Service Action: Retorque Stiffening Plate Bolts on Front and Rear Axle

I12 (i8)

Front stiffening plate

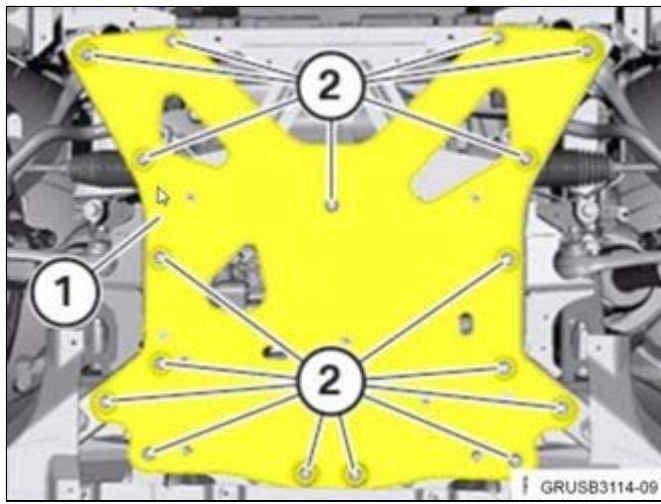
Remove the front underbody protection per RA 51 47 490, "Removing and installing/replacing underbody protection (front)."

- Release the screws (arrows).
- Remove the underbody protection.
- Reinstall torque screws to:
 - No metric head, 3 Nm
 - With metric head, 5 Nm

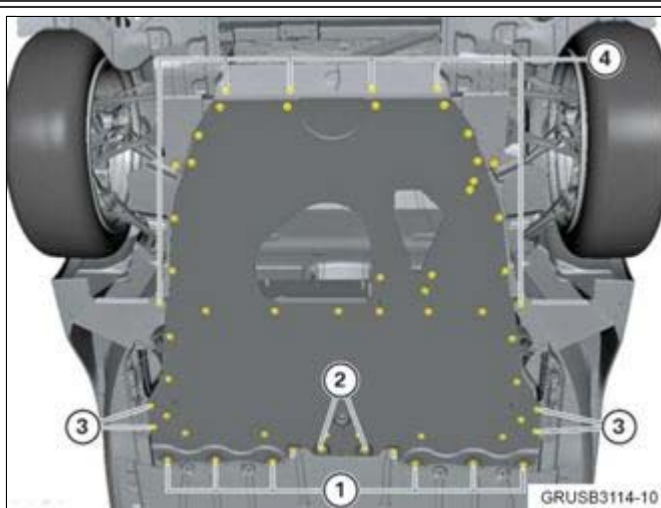
Retorque all 17 bolts (2) M8x21 (Torx T50).
Loosen them one by one (approx. 45 degrees) and retorque one by one to 28 Nm.

Note: Loosen and retorque each screw before starting the next one.
